## Staff Report to the Planning Commission

Application Number: **05-0388**

Project Description: Proposal to create 28 residential townhouse lots with common open space and construct 28 townhouses.

1/8" Floor Plans  
Lots 1 & 2

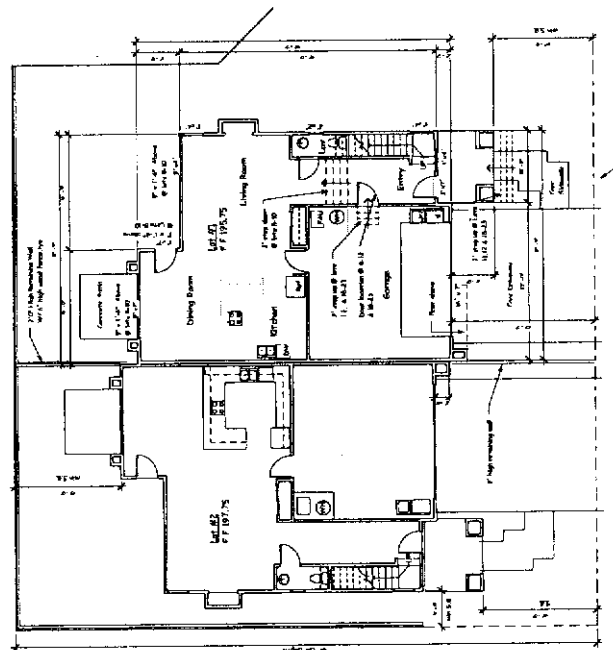
(Note: The toilet issue also appears for the market rate unit on Lot 15 and on sheet A4 for Lots 1 and 2. In addition there are incomplete drawings on market rate units on Lots 15 and 13 with regard to missing doors and/or bath fixtures.)
